# Site Accessibility Evaluation

**Office of the Sheriff**

**Accessibility Evaluation**

***Inspection Date: 05/18/2020  
Inspector: David Mejia***

### Finding: 1

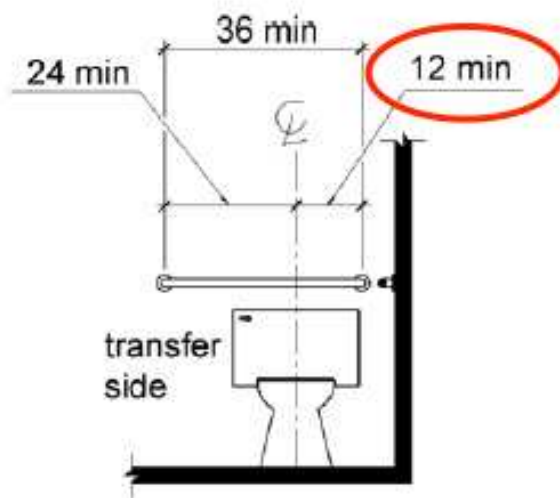
The rear grab bar does not extend adequately past the centerline of the toilet on the wall side.

11.25 inches from side wall

Re-position rear grab bar to extend from the centerline of the toilet 12 inches minimum to the wall side and 24 inches minimum to the transfer/open side.

### Finding: 2

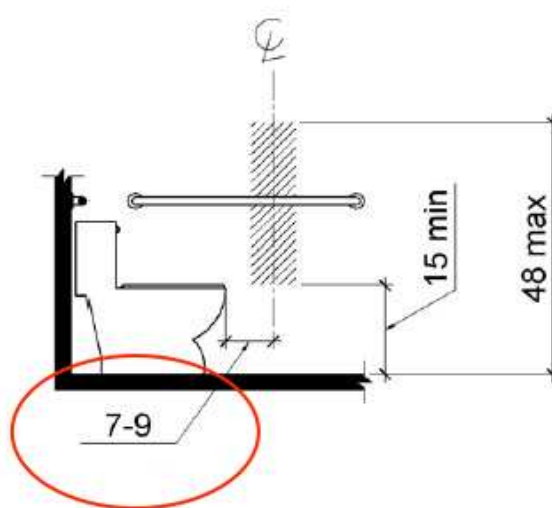
The toilet paper is not installed within the compliant range.

10 inches in front of toilet measured to the centerline of the dispenser

Re-position toilet paper dispenser to be within 7 inches minimum to 9 inches maximum in front of the toilet measured to the centerline of the dispenser.

### Finding: 3

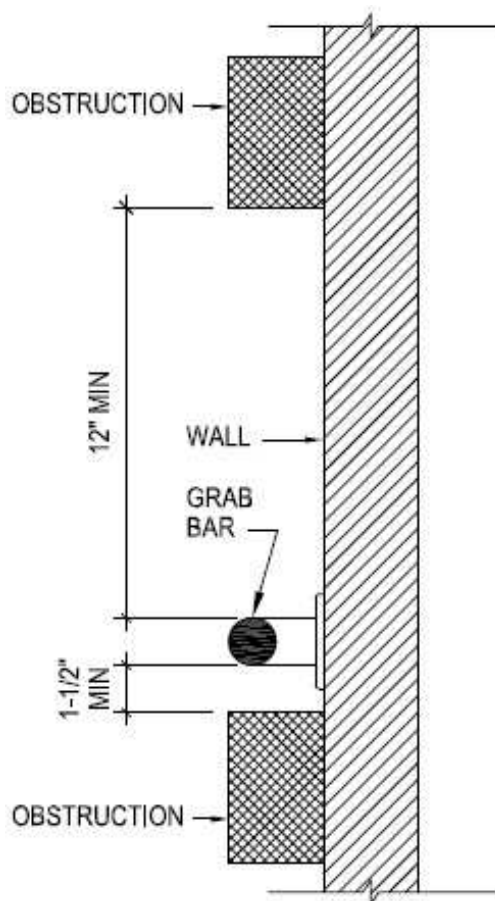
The toilet seat cover dispenser is mounted too close to the top of the grab bar, minimizing the gripping surface.

5 inches above side  
grab bar

Relocate seat cover dispenser to have operable part between 15 inches minimum and 48 inches maximum above floor. May require relocation below rear or side grab bar at 1.5 inches minimum clearance below grab bar to meet compliance.

### Finding: 4

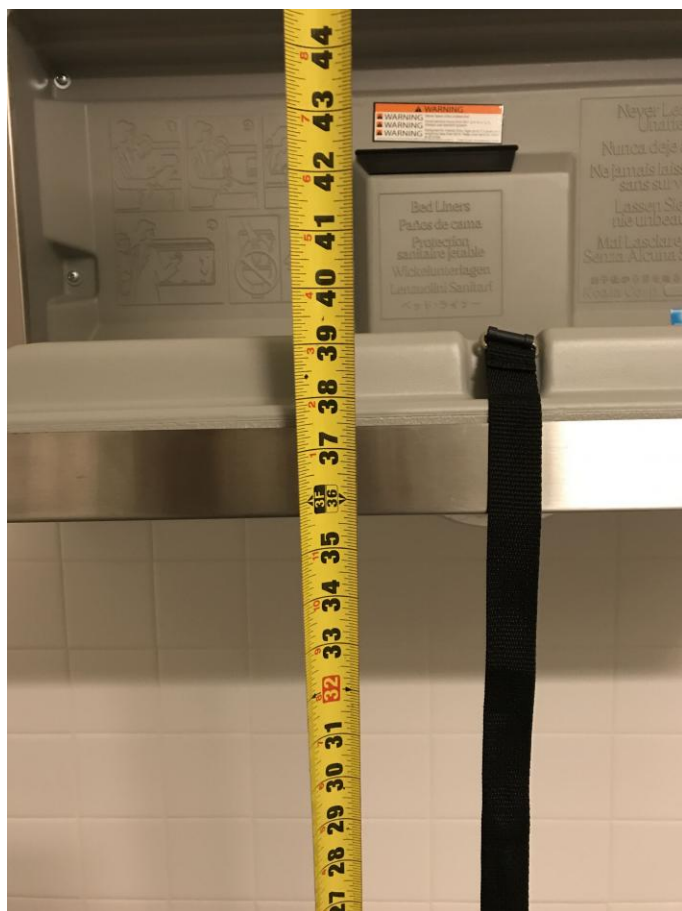
The baby changing table is too high when folded down.

39 inches above finish floor to the top of the table surface

Lower baby changing station to meet the 27 inches minimum required under an element for knee clearance, 28 inches minimum to 34 inches maximum to the top of the table surface and not to exceed 48 inches maximum height to operable part measured from the finished floor.

### Finding: 6

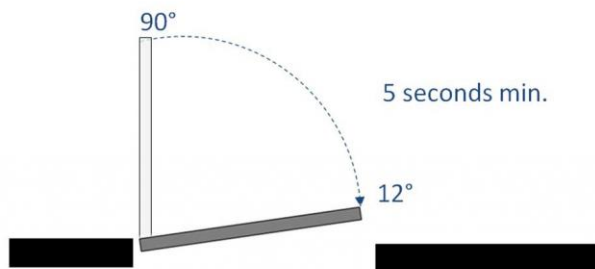
The door is equipped with a door closer and returns to a closed position too quickly.

Door returns to a closed position in under 5 seconds

Adjust door closer to allow a minimum of 5 seconds to move from the open position at 90 degrees to 12 degrees from the latch/locking mechanism.

### Finding: 7

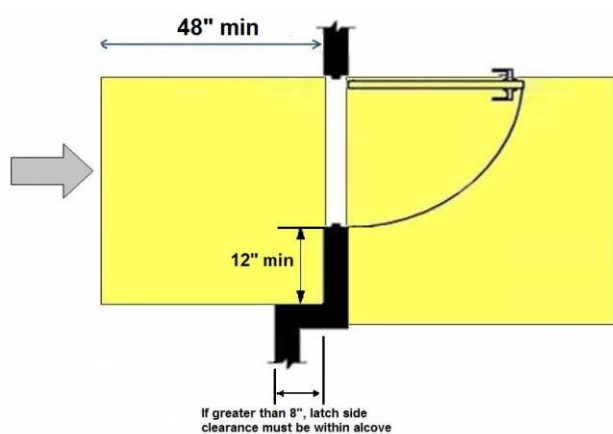
The door is equipped with both a closer and a latch and is recessed on the latch side greater than 8 inches deep. There is no latch side clearance within the alcove.

Door recessed on  
latch side 10.5 inches  
deep

Replace door and door frame that eliminates the alcove or install an automatic door opener.

### Finding: 8

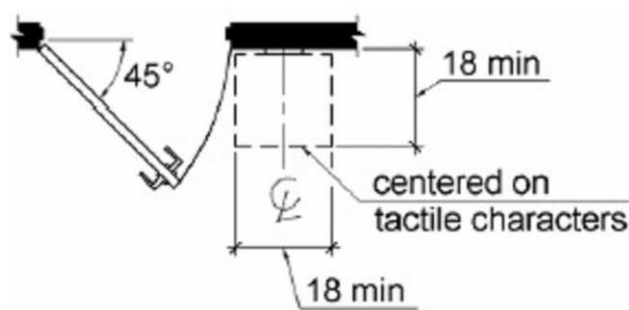
Clear floor space is not provide at the tactile door sign.

Clear floor space is not provided beyond the arc of the door

Re-position sign so that it is centered on a clear floor space of 18 inches by 18 inches minimum beyond the edge of the latch side of the door. Also, door sign may be installed on push side of door.

#### Finding: 9

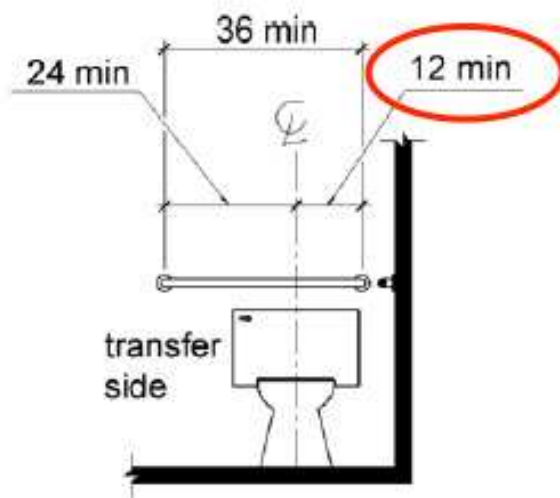
The rear grab bar does not extend adequately past the centerline of the toilet on the wall side.

11 inches from side wall

Re-position rear grab bar to extend from the centerline of the toilet 12 inches minimum to the wall side and 24 inches minimum to the transfer/open side.

#### Finding: 10

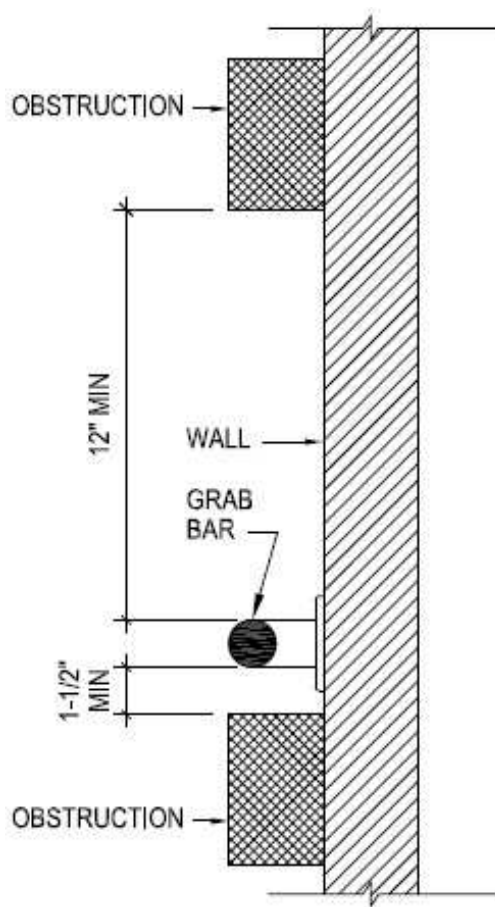
The toilet seat cover dispenser is mounted too close to the top of the grab bar, minimizing the gripping surface.

8.75 inches above side  
grab bar

Relocate seat cover dispenser to have operable part between 15 inches minimum and 48 inches maximum above floor. May require relocation below rear or side grab bar at 1.5 inches minimum clearance below grab bar to meet compliance.

#### Finding: 11

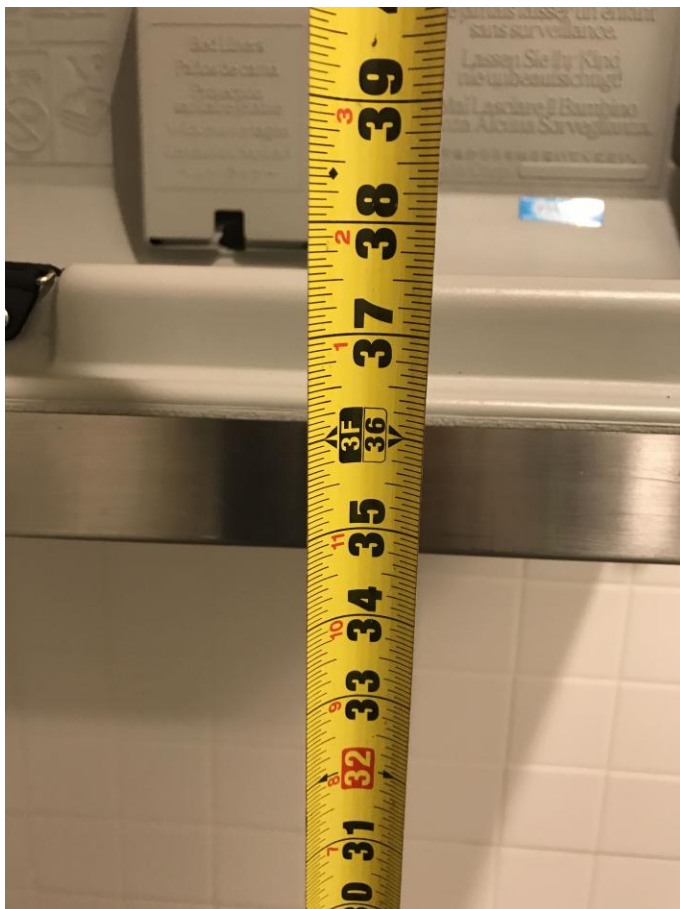
The baby changing table is too high when folded down.

39 inches above finish floor to the top of the table surface

Lower baby changing station to meet the 27 inches minimum required under an element for knee clearance, 28 inches minimum to 34 inches maximum to the top of the table surface and not to exceed 48 inches maximum height to operable part measured from the finished floor.

#### Finding: 12

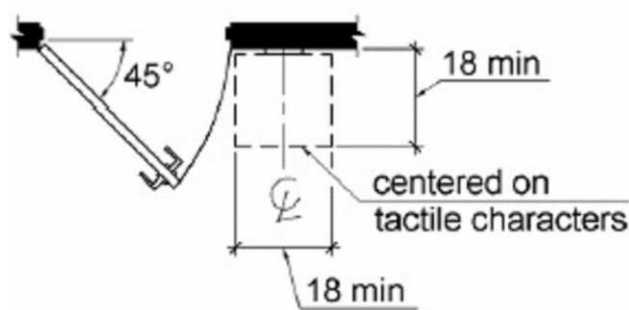
Clear floor space is not provide at the tactile door sign.

Clear floor space is not provided beyond the arc of the door

Re-position sign so that it is centered on a clear floor space of 18 inches by 18 inches minimum beyond the edge of the latch side of the door. Also, door sign may be installed on push side of door.

#### Finding: 14

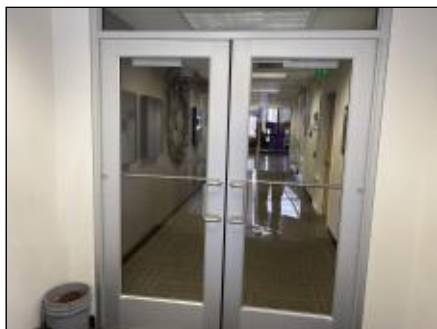
Although automatic door openers are not required, it is highly recommended due to the amount of pedestrian traffic from staff. Also, a community room where public meetings and trainings are held is located on the 3rd floor.

Extremely heavy exterior doors

Install automatic door openers. One opener for exterior doors and one opener for interior doors.
